Wisconsin Department of Transportation

Proposal #17: 2070-03-71, WISC 2019 288

W LAYTON AVENUE

This is Addendum No. 01, which provides for the following:

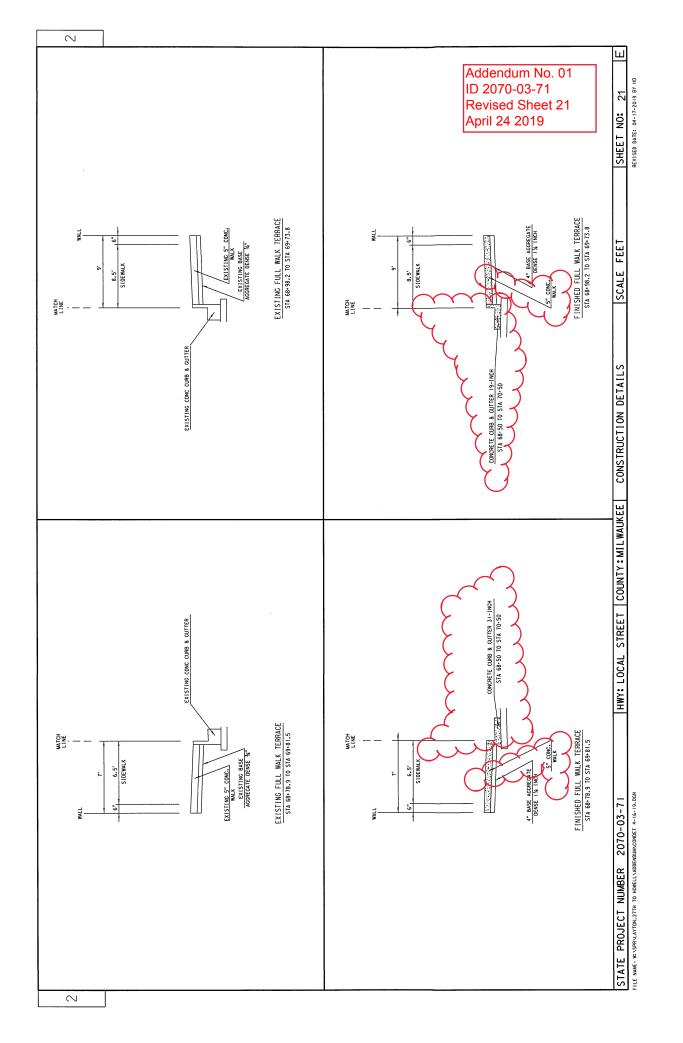
Revised Plan Sheets
Plan Sheet	Plan Sheet Title (brief description of changes to sheet)
21	Construction Details (revised detail named Finished Full Walk Terrace STA 68+78.9 to STA 69+81.5 to correct callout 5" CONC. WALK. Revised detail named Finished Full Walk Terrace STA 68+78.9 to STA 69+81.5 to correct callout CONCRETE CURB & GUTTER 31-INCH STA 68+50 TO STA 70+50. Revised detail named Finished Full Walk Terrace STA 68+78.9 to STA 69+81.5 to delete 1' dimension. Revised detail named Finished Full Walk Terrace STA 68+78.9 to STA 69+81.5 to add tie bars. Revised detail named Finished Full Walk Terrace STA 68+98.2 to STA 69+73.8 to correct callout 5" CONC. WALK. Revised detail named Finished Full Walk Terrace STA 68+98.2 to STA 69+73.8 to correct callout CONCRETE CURB & GUTTER 19-INCH STA 68+50 TO STA 70+50. Revised detail named Finished Full Walk Terrace STA 68+98.2 to STA 69+73.8 to add tie bars. Revised detail named Finished Full Walk Terrace STA 68+98.2 to STA 69+73.8 to delete 1' dimension.

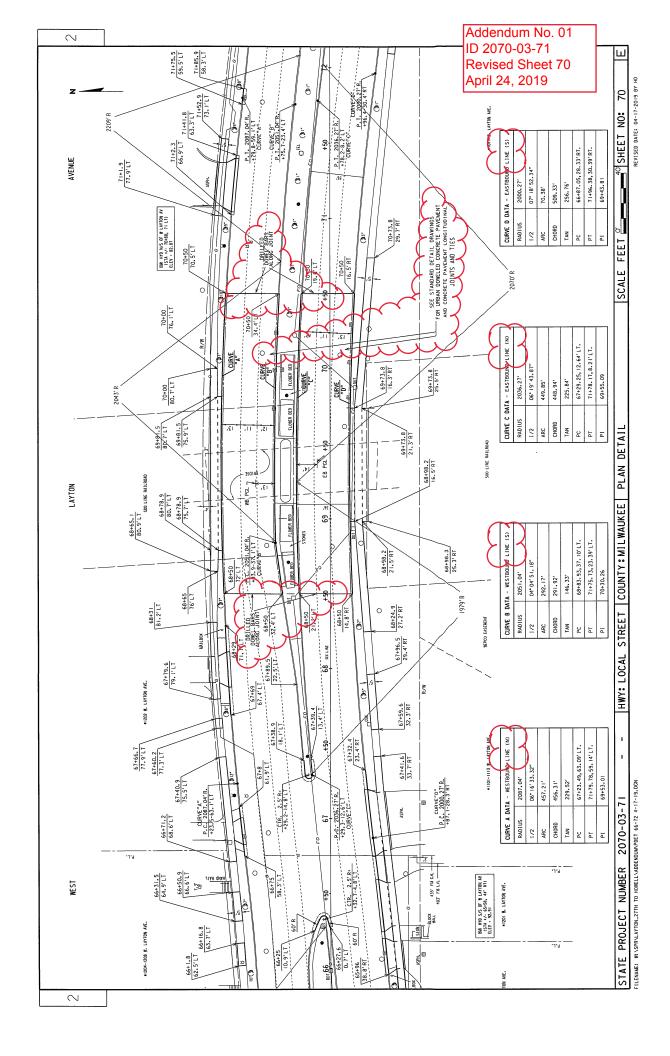
70	Plan Details (revised construction joints at STA 68+50 to add drilled dowel bars along joints. Revised construction joints at STA 70+50 to add drilled dowel bars along joints. Revised concrete pavement plan layout to add note for contractor to see standard detail drawings for Urban Doweled Concrete Pavement. Revised concrete pavement plan layout to add note for contractor to see standard detail drawings for Concrete Pavement Longitudinal Joints and Ties. Revised Curve Data A Data table for revised name showing curve along westbound line (N). Revised Curve Data B Data table for revised name showing curve along eastbound line (N). Revised Curve Data D Data table for revised name showing curve along eastbound line (S).
209	Street Lighting Details (revised detail named TYPICAL CONDUIT INSTALLATION FROM PULL BOX TO POLE & 4" X 4" WIRING PEDESTAL to revise metal wiring pedestal 4" X 4" X 36" back panel for detail of approximate area of access hole)

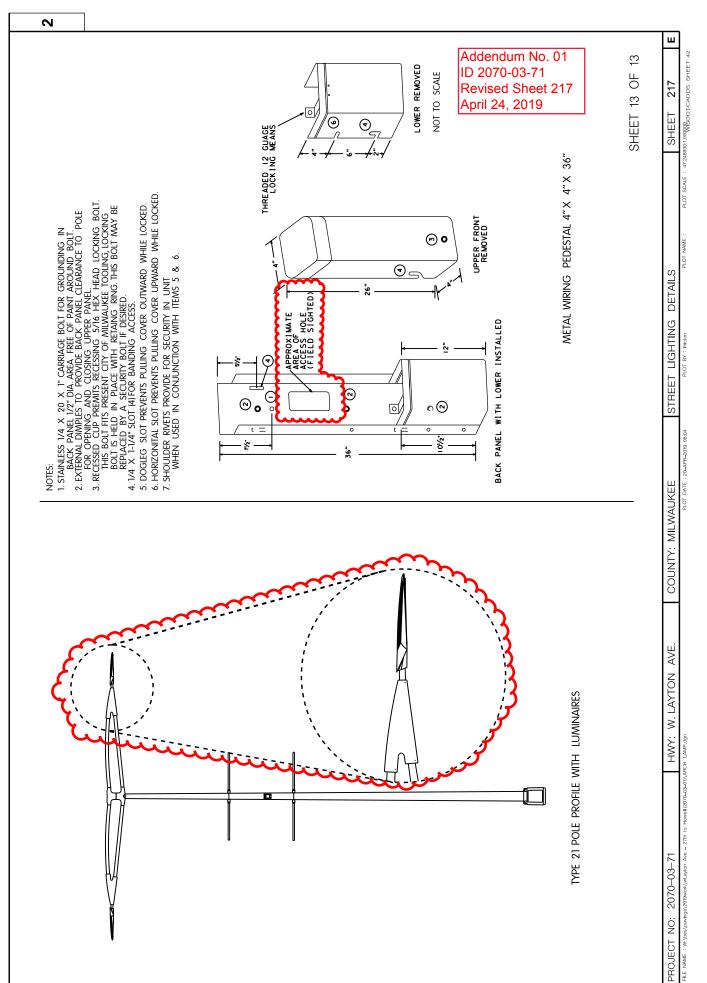
217	Street Lighting Details (revised detail named TYPE 21 POLE PROFILE WITH LUMINAIRES to allow all details to be visible. Revised detail named Metal Wiring Pedestal 4" X 4" X 36" to revise back panel for detail of approximate area of access hole
249	Miscellaneous Quantities (revised quantity sheet to correct name for item SPV.0060.305 STREET LIGHTING SINGLE BRACKET ARM 8'. Revised quantity sheet to correct name for item SPV.0060.306 STREET LIGHTING DOUBLE BRACKET ARM 8'. Revised quantity name to correct name for item SPV.0060.308 POLE TYPE 21 ALUMINUM WITH TRANSFORMER BASE)

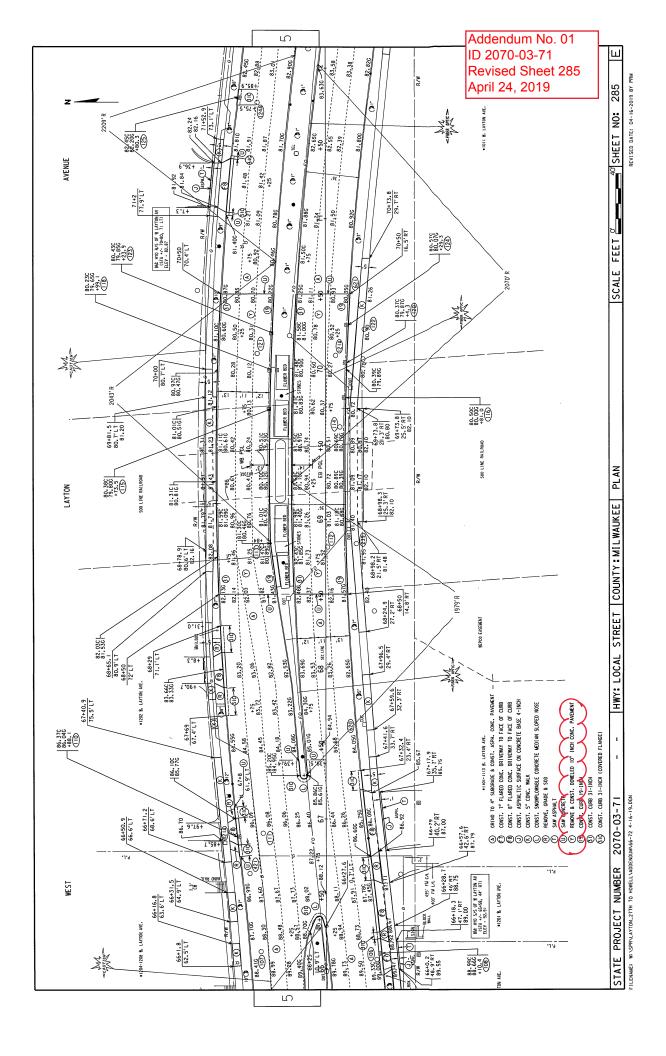
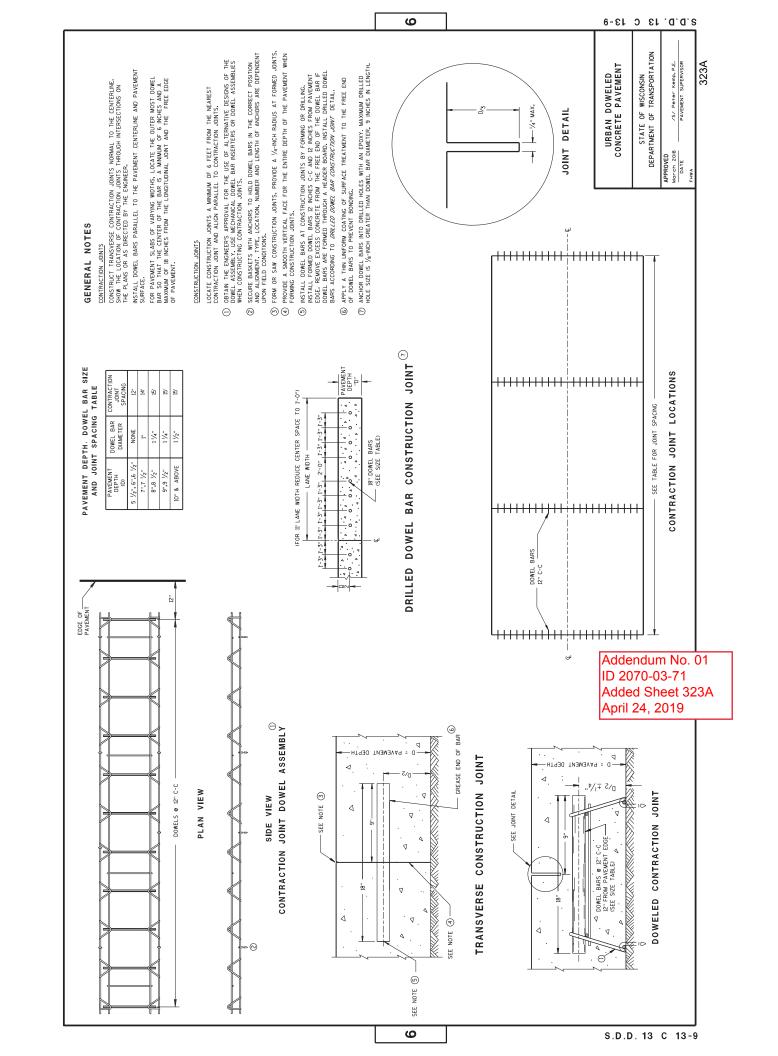
250	Miscellaneous Quantities (revised quantity sheet to revised quantity and name for item SPV.0060.314 STREET LIGHTING SINGLE BRACKET ARM 8' SPARE. Revised quantity sheet to correct name for item SPV.0060.313 POLE TYPE 21 ALUMINUM WITH TRANSFORMER BASE SPARE. Revised quantity sheet to correct name for item SPV.0060.315 STREET LIGHTING DOUBLE BRACKET ARM 8' SPARE)
256	Miscellaneous Quantities (revised quantity sheet to add additional item DRILLED DOWEL BARS at STA 68+50 and STA 70+50)
285	Plan (revised legend item to correct details of concrete pavement)
